Docket Item # 2
BAR CASE #2008-0234

BAR Meeting
April 7, 2010

ISSUE: Alterations and Signage

LOCATION: 134 North Royal Street (Gadsby's Tavern)

Graphic 4: "Hatch" Area

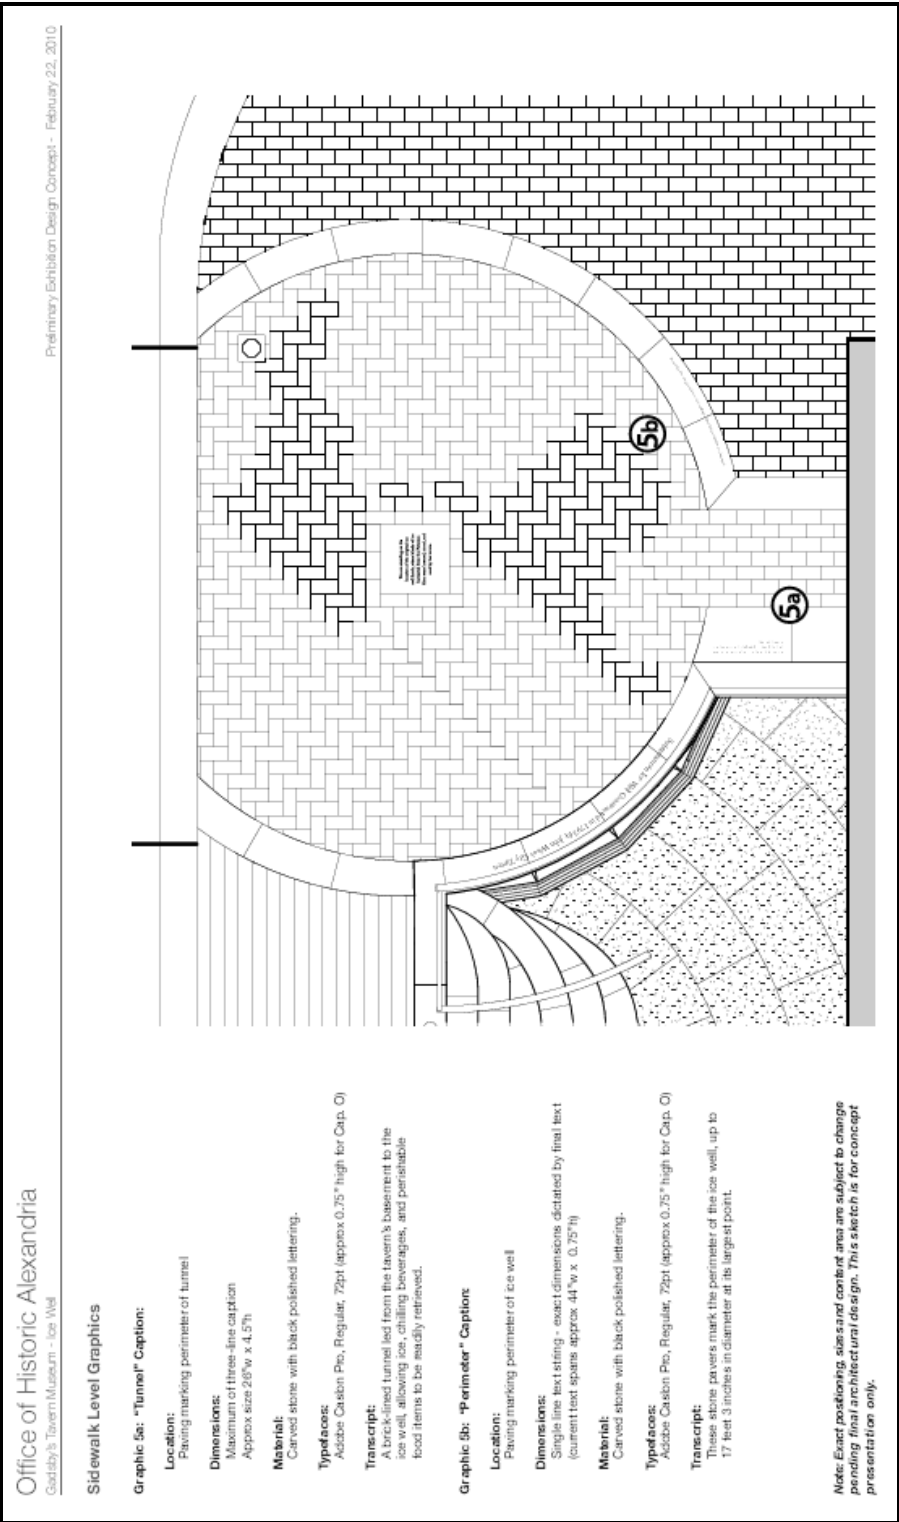
The applicant has addressed the outstanding issues remaining in the conditional approval raised by the Board at the February 17, 2010 public hearing. The current design for the interpretive signage for the ice well is as follows:

1. Sidewalk level interpretive text carved into stone with black polished lettering.
2. Interpretive text etched into cast glass recessed into paving marking the original location of ice well's hatch.
3. Interpretive text carved into stone with black polished lettering located on the capping stones above viewing windows.
4. Carved stone photo etching of John Gadsby's 1805 advertisement located on capping stones above wall adjacent to viewing windows.
5. Cast bronze engraved donor plaque (not to exceed 18"x 24") horizontally centered on the tunnel walk, 6 inches bellow capping stone.

Graphic 3: Donor Plaque

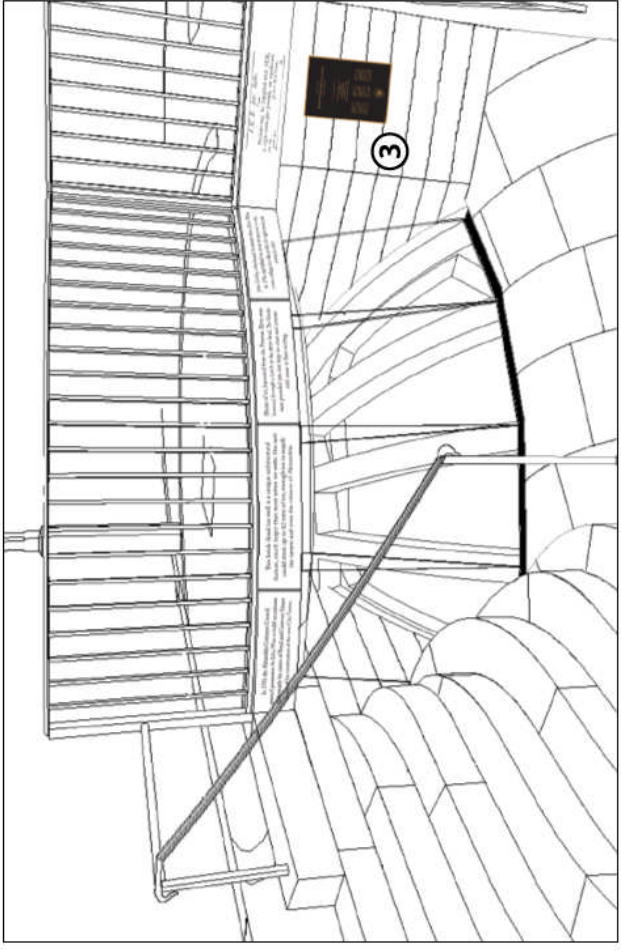
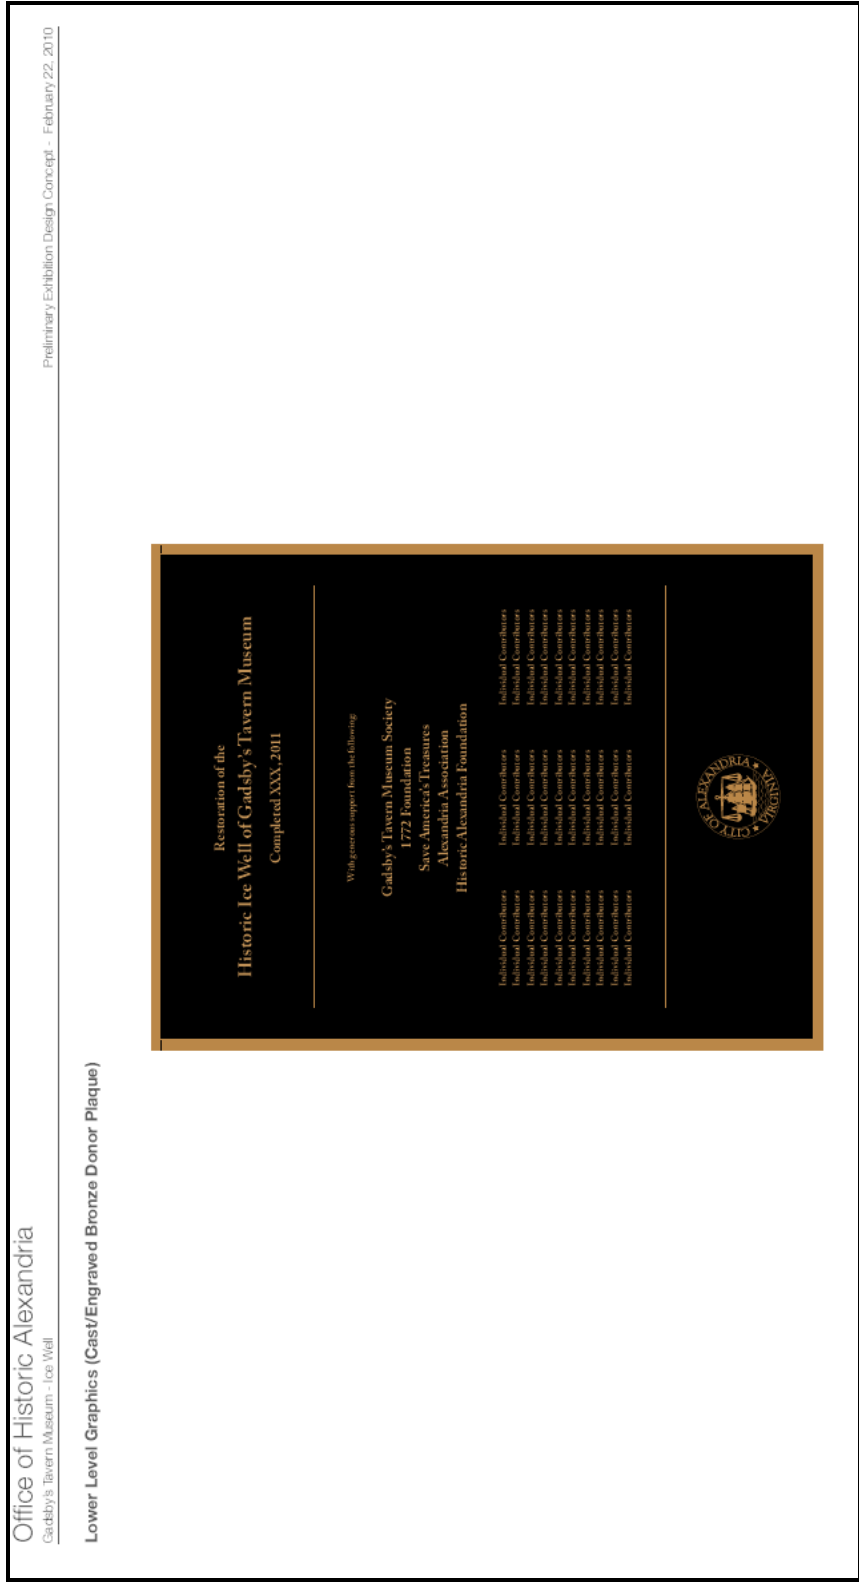
At the February 17, 2010 hearing, the applicant, at the Board's request, responded to the conditions of their approved Certificate of Appropriateness. The Board was still concerned about the proposed amount of graphic information and the use of plastic for two of the signs. Two additional modifications were recommended for restudy prior to final approval:

1. Replace the laminated donor's panel with a bronzed metal plaque; and
2. Delete the laminated info panel which was to be located in the below grade on the City Hotel foundation wall.
